## ERRATA WIRING INSTRUCTIONS FOR 122385B ON/OFF SWITCH

Figure 1.

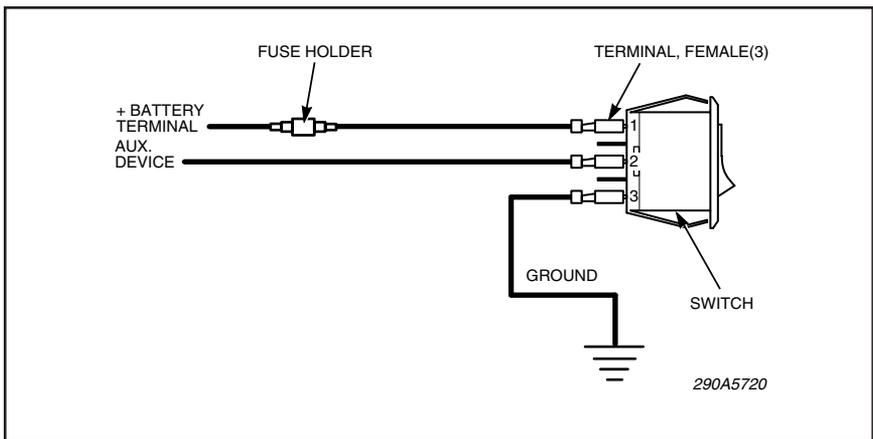
Current wiring instructions may cause the indicator lamp to remain illuminated in the switch's "OFF" position. See figure 1. To eliminate the problem, the 12V common battery lead is connected to terminal 1. Terminal 2 connects to the auxiliary device.
